## MOC Creek Diversion Plan

**Document Number:** MGOOC-1779562647-10971

**Version:** 3.0

2-1 – Mt Owen Complex Creek Diversions

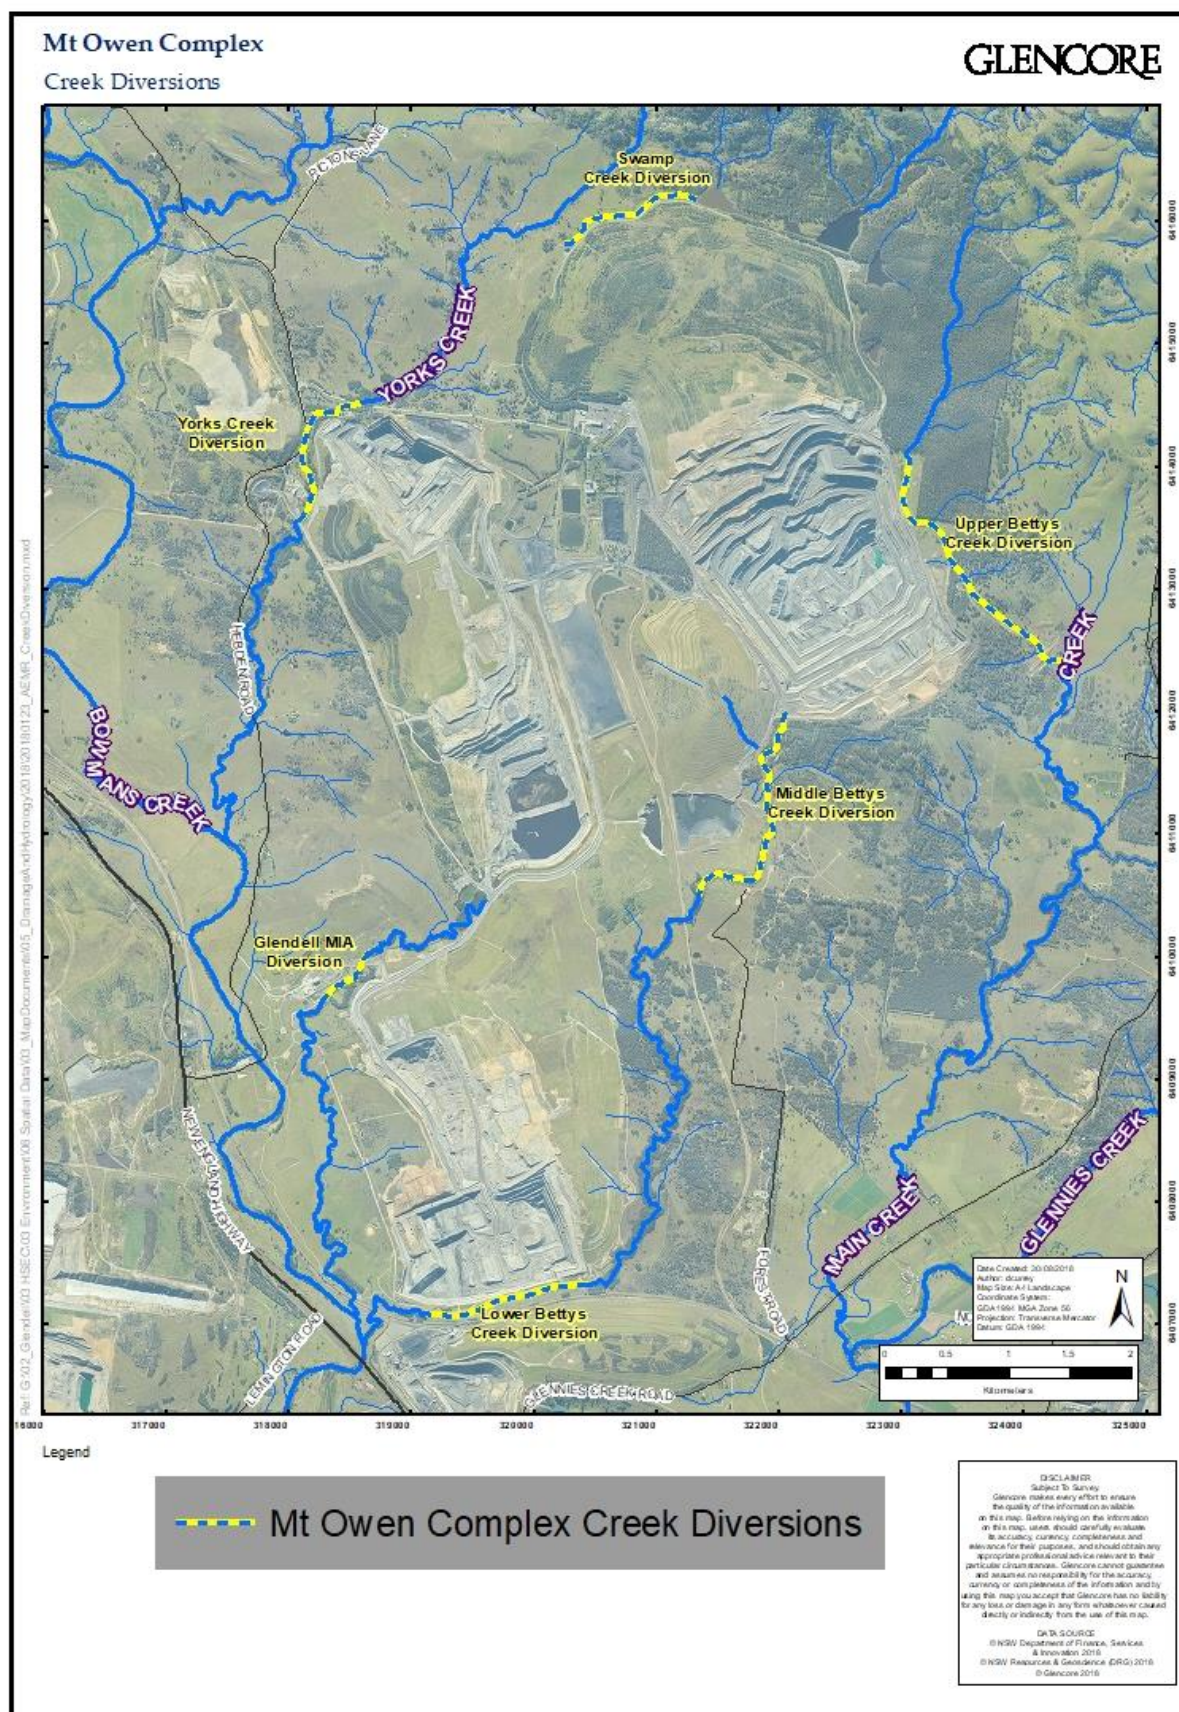
- See Figure 2-1 – Please update to be clearer and more descriptive.
